## **Proposal for editorial correction to ECE/TRANS/WP.29/GRE/2012/39**

Supplement 17 to Regulation No. 87 (Daytime running lamps)

Note: During the preparation of ECE/TRANS/WP.29/GRE/2012/39 it was omitted to take into consideration the content of ECE/TRANS/WP.29/2012/78 that has been submitted for adoption by WP219 at its 158<sup>th</sup> session. The corrected text included below is intended to completely replace the content of ECE/TRANS/WP.29/GRE/2012/39 and the changes are identified in the "track changes" shown in the right hand column.

Figure 1a

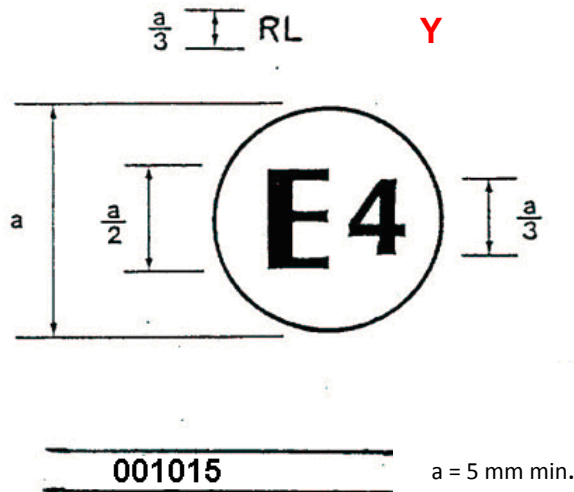
Annex 2, Insert new example of the approval mark, to read (the amendment is marked in RED):

The lamp bearing the approval mark shown above has been approved in the Netherlands (E4) under number 001015 as a part of an interdependent lamp system composing a daytime running lamp. The approval number indicates that the approval was granted according to the requirements of this Regulation in its original (un-amended) form. "
